WBSC1 (D0901140)
LBSC1 (D0900445)
(ITMy)

WBSC3 (D0901149)
LBSC3 (D0900495)
(ITMx)

WBSC9 (D0901153)
LBSC4 (D0900478)
(ETMx)

WBSC10 (D0901157)
LBSC5 (D0900517)
(ETMy)

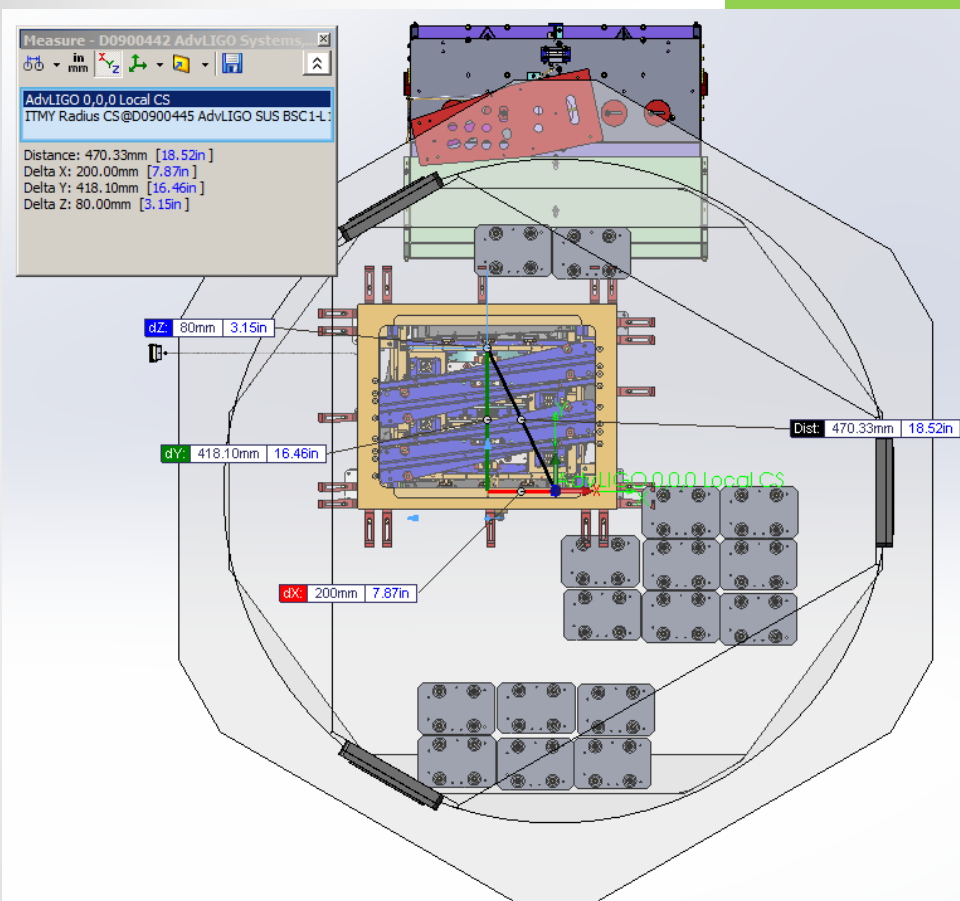
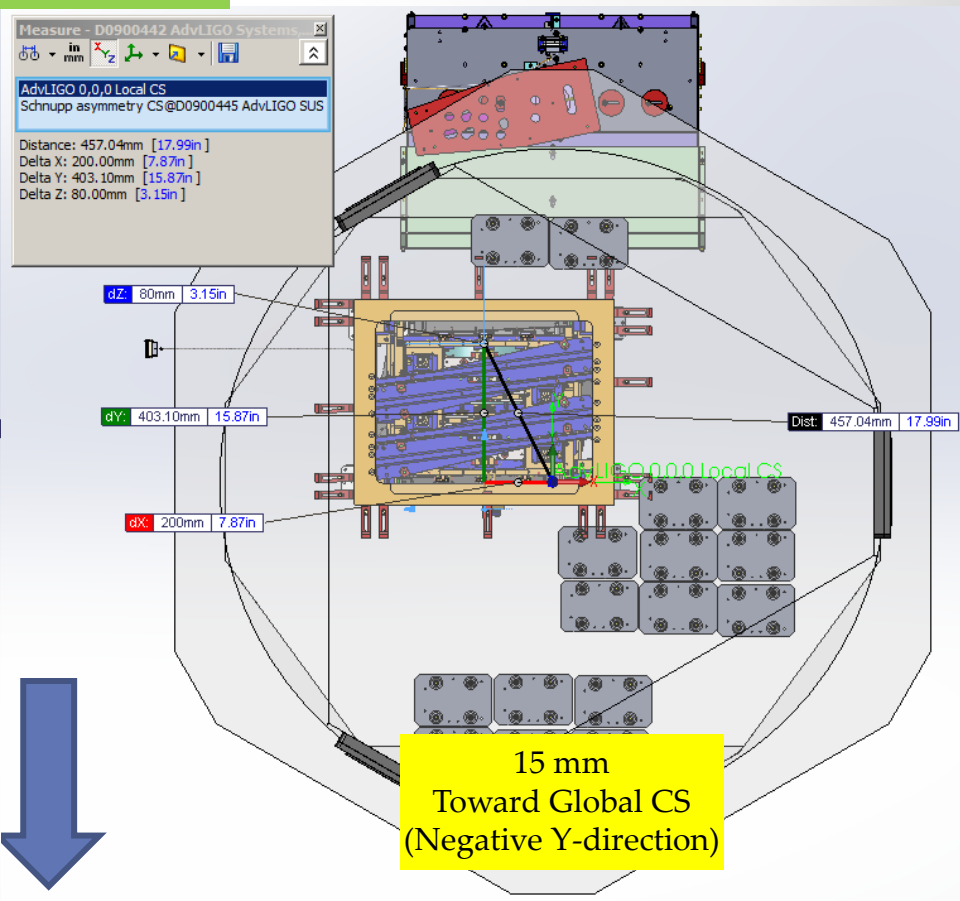
Original Local Coordinates:
 $X = -200.0 \text{ mm}$
 $Y = 418.10 \text{ mm}$
 $Z = -80.0 \text{ mm}$

New Local Coordinates:
 $X = -200.0 \text{ mm}$
 $Y = 403.10 \text{ mm}$
 $Z = -80.0 \text{ mm}$

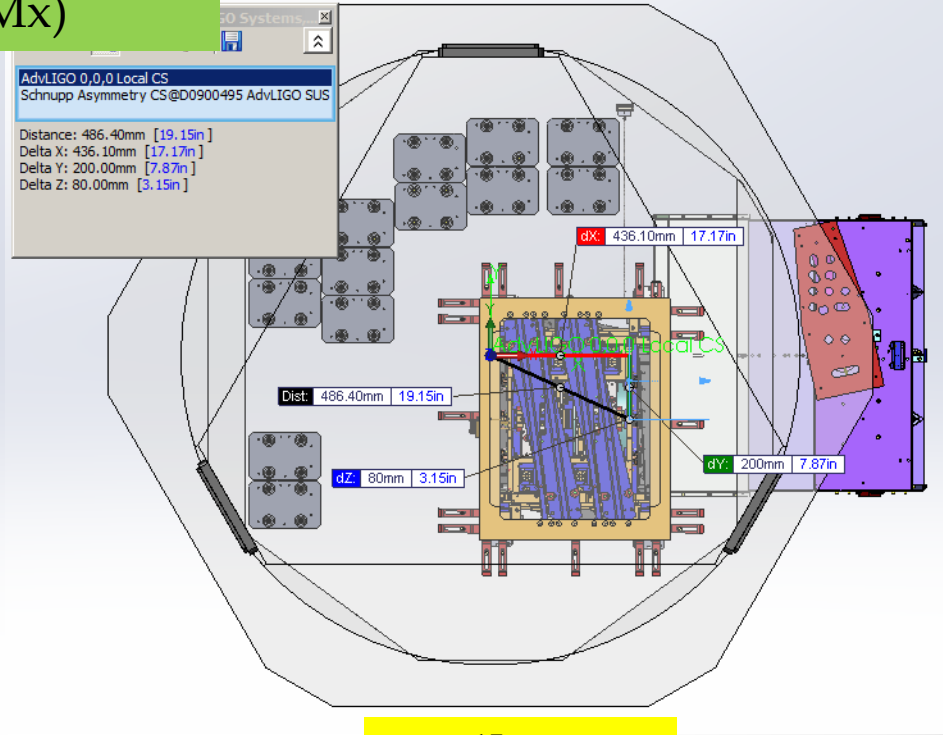
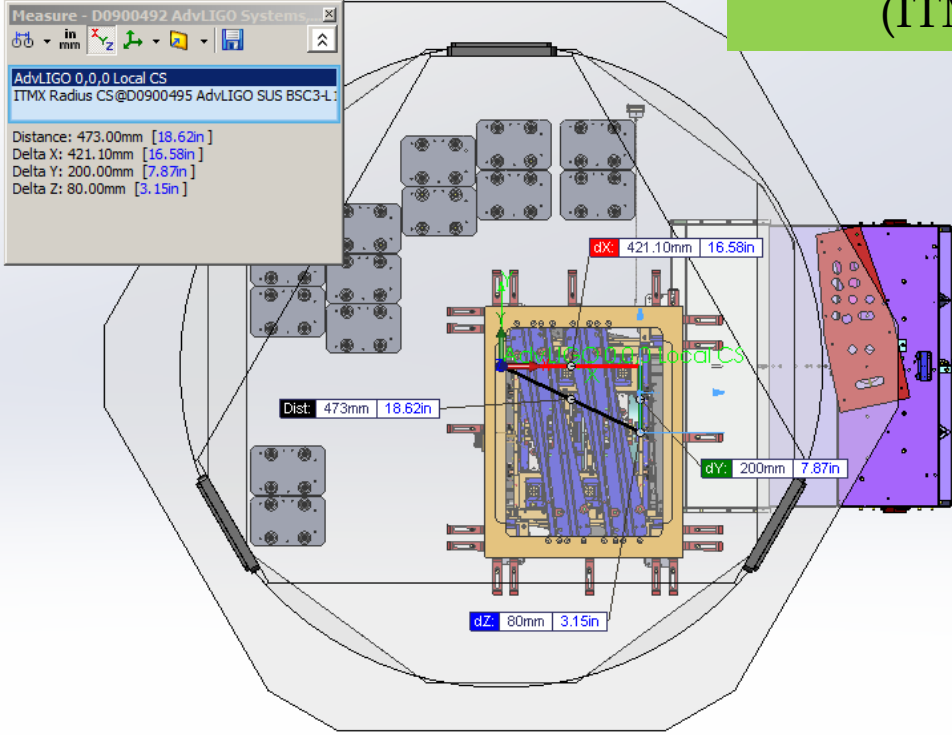
15 mm
Away from Global CS
(Positive X-Direction)

Original Local
Coordinates:
X = 418.0 mm
Y = -200.0 mm
Z = -80.0 mm

New Local Coordinates:
X = 433.0 mm
Y = -200.0 mm
Z = -80.0 mm

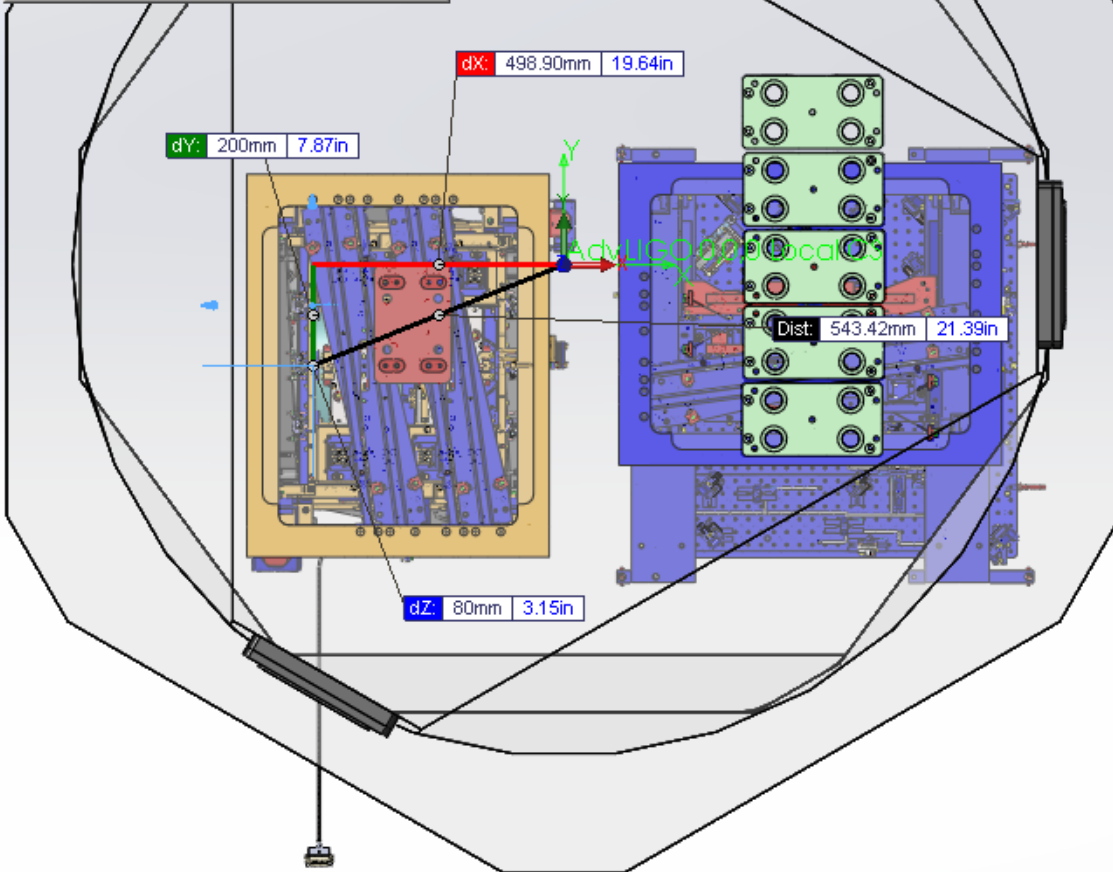
NO
CHANGE

Local
Coordinates:
X = -502.0 mm
Y = -200.0 mm
Z = -80.0 mm

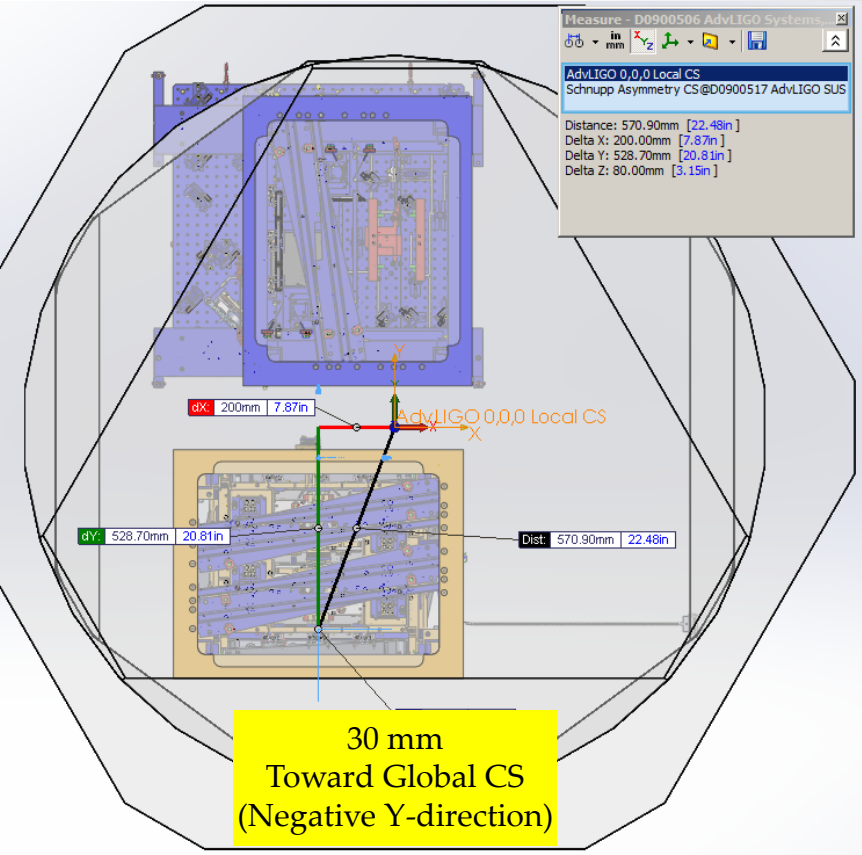
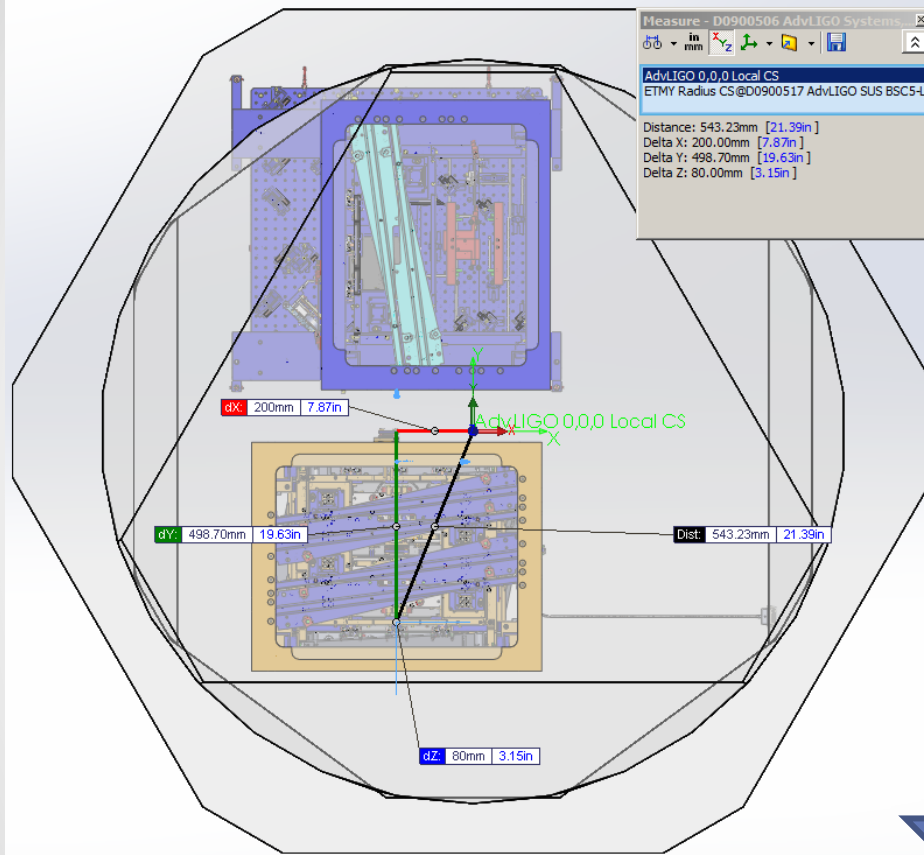
Original Local
Coordinates:
X = -200.0 mm
Y = -501.9 mm
Z = -80.0 mm

New Local Coordinates:
X = -200.0 mm
Y = -531.9 mm
Z = -80.0 mm
